**STAFF RECOMMENDATION**  
**311 Chapel Avenue**  
**August 19, 2020**

**Application:** New Construction—Addition  
**District:** Eastwood Neighborhood Conservation Zoning Overlay  
**Council District:** 06  
**Map and Parcel Number:** 08302015700  
**Applicant:** Cheyenne Smith  
**Project Lead:** Melissa Baldock, melissa.baldock@nashville.gov

<p><b>Description of Project:</b> Application is to construct a rear and side addition to the house.</p> <p><b>Recommendation Summary:</b> Staff recommends approval of the proposed outbuilding with the following conditions:</p> <ol style="list-style-type: none"><li>1. The DADU permit HCP 2019047674 not be renewed;</li><li>2. Staff approve the windows and doors and the metal roof color and design prior to purchase and installation; and</li><li>3. MHZC approve the location of the HVAC and other utilities.</li></ol> <p>With this condition, staff finds that the project meets Sections II.B. and III.B. of the Eastwood Neighborhood Conservation Zoning Overlay design guidelines.</p>	<p><b>Attachments</b> <b>B:</b> Site Plan <b>C:</b> Elevations</p>
---	--

Figure 2. The outbuilding shown on the site plan represents a garage that could be built if this addition is approved.

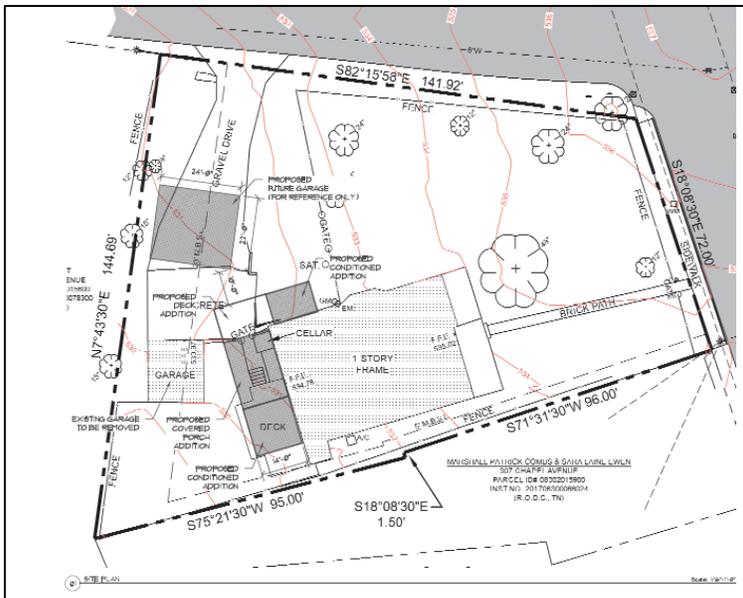
**Background:** 311 Chapel Avenue was constructed c. 1900 and is a contributing house within the Eastwood Neighborhood Conservation Zoning Overlay (Figure 1). The house sits on a large, irregularly shaped lot at the corner of Chapel and Sharpe Avenues. It has a deep front setback and is oriented toward Chapel. In August 2019, MHZC approved a Detached Accessory Dwelling Unit adjacent to the house, but that structure has not been constructed. That permit will expire on August 22, 2020. If this addition is approved, staff recommends not renewing the DADU permit HCP 2019047674 because of the DADU's proximity to the proposed addition. The footprint of the outbuilding shown on the site plan represents a smaller outbuilding that could be constructed with this addition while maintaining an appropriate setback from the Sharpe Avenue side street and the (Figure 2).

Setback & Rhythm of Spacing: The addition meets all base zoning setbacks. It will be ten feet (10’) from the left façade, over seventy-five (75’) from the right, and approximately thirty feet (30’) from the rear. Because of the odd shape of the lot, the previously approved DADU is located to the side of the addition, but its size would not result in an adequate distance of 20’ between the addition and DADU. If this addition is approved, staff recommends not renewing the DADU permit HCP 2019047674 because of the DADU’s proximity to the proposed addition. The footprint of the outbuilding shown on the site plan represents a smaller outbuilding that could be constructed with this addition while maintaining an appropriate setback from the Sharpe Avenue side street and the (Figure 2).

With the condition that the DADU permit HCP 2019047674 not be renewed, staff finds that the proposed additions meet Sections II.B.1.c. and II.B.2. of the design guidelines.

Figure 2. The area indicated with the box is the area to be reconstructed.

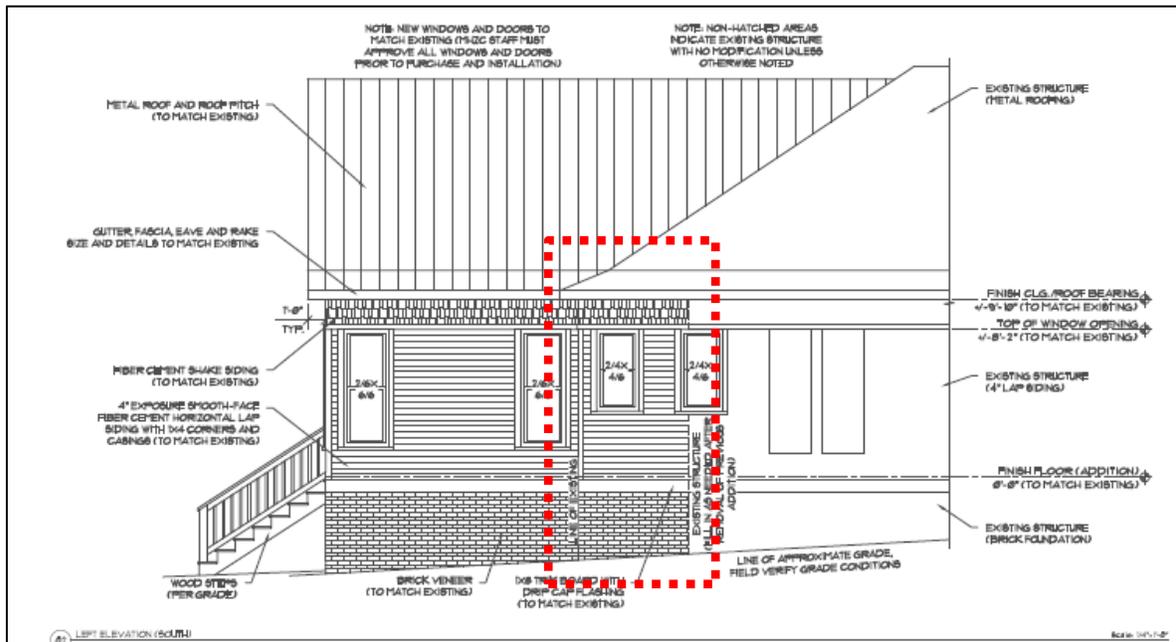
**Partial Demolition:** The applicant plans to reconstruct a rear portion of the on the left façade, which was a previous addition (Figure 1). This is considered partial demolition. Staff finds the reconstruction to be appropriate because it will match the foundation, eave, and ridge height of what is existing. The new window pattern will be scaled appropriately and the partial demolition will result in an addition and fenestration pattern that still meets the design guidelines.

Staff finds that the proposed partial demolition on the left side façade meets Section III.B.2 for appropriate demolition and do not meet section III.B.1 for inappropriate demolition.

Figure 3. The side addition will be behind the bay on this right façade.

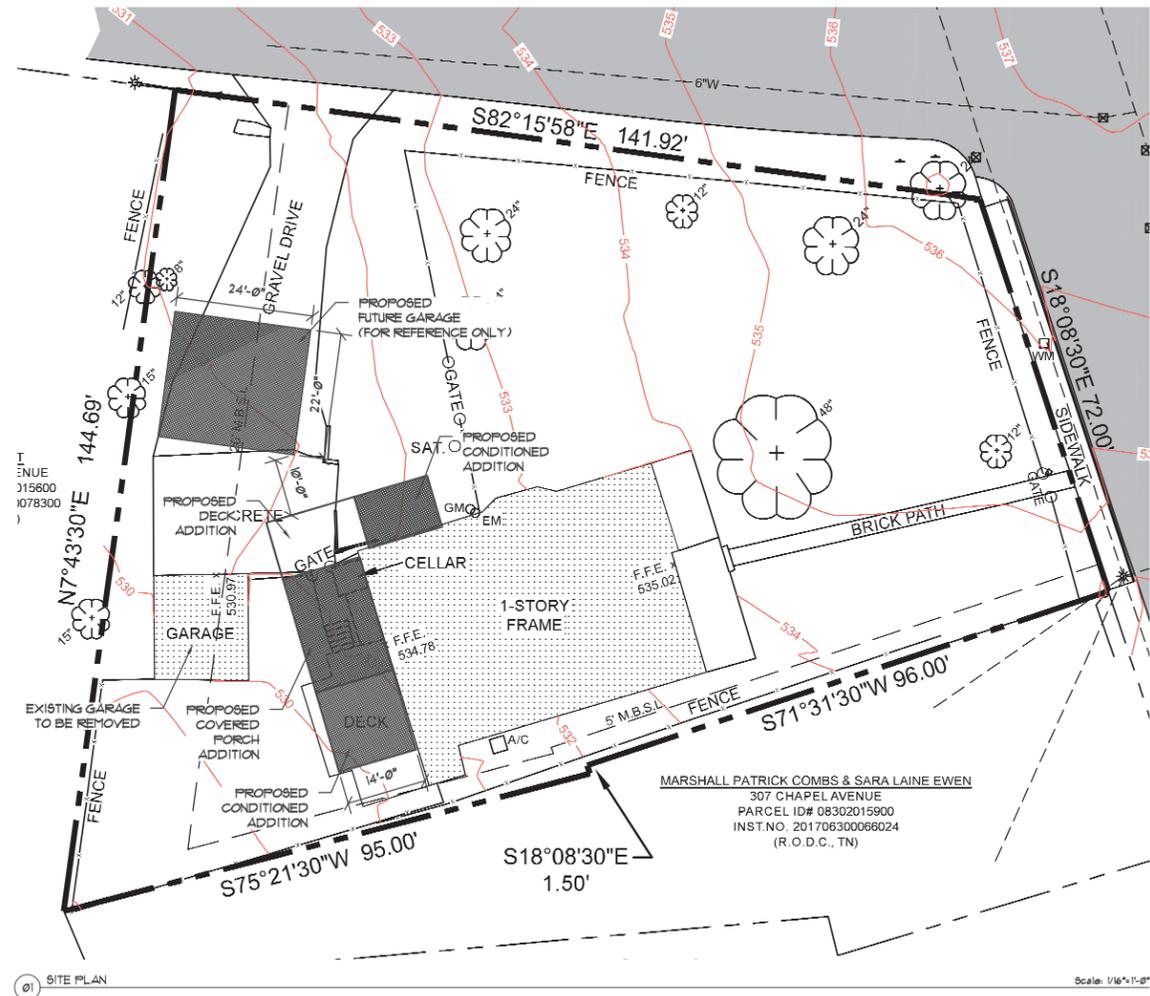
**Height & Scale:** The applicant proposes a side addition on the right façade. Staff finds that the side addition is appropriate for this house because at seventy-two feet (72') wide at the front and one hundred and forty-four feet (144') wide at the rear, the lot is much wider than the typical lot in the immediate vicinity. The proposed side addition meets all the design guidelines for side additions. It is located in the back half of the house, does not wrap the back corner, has a side gable roof form, and at nine foot, four inches (9'4") wide is less than one-half the width of the historic house. It is at least two feet (2') shorter than the historic house and will not interfere with any significant architectural features (Figure 3). The side addition will be about nine feet (9') wide and thirteen feet, four inches (13'4") deep.

The rear addition will be one-and-half stories in height. Its eave and foundation height will match those of the historic house. Its ridge height will be one foot (1') lower in height than that of the historic house. The addition will be inset one foot (1') from each of the back corners for its entire depth of fourteen feet (14'). The rear addition's footprint will be about four hundred and ninety square feet (490 sq. ft.).

Staff finds that the addition's height and scale meet Sections II.B.1.a., II.B.1.b., and II.B.2. of the design guidelines.

SITE PLAN

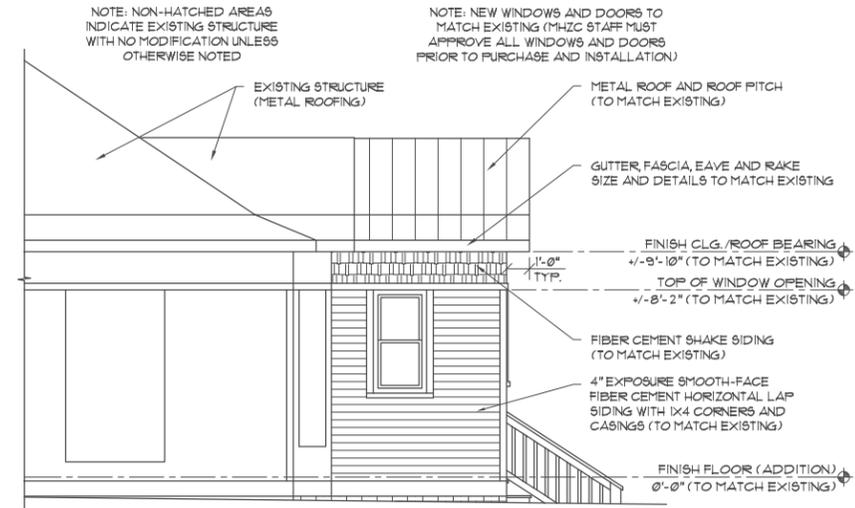
Appurtenances & Utilities: No changes to the site's appurtenances were indicated on the drawings. The location of the HVAC and other utilities was also not noted. Staff recommends that the HVAC be located on the rear façade, or on a side façade beyond the midpoint of the house.

4. The DADU permit HCP 2019047674 not be renewed;
5. Staff approve the windows and doors and the metal roof color and design prior to purchase and installation; and
6. MHZC approve the location of the HVAC and other utilities.
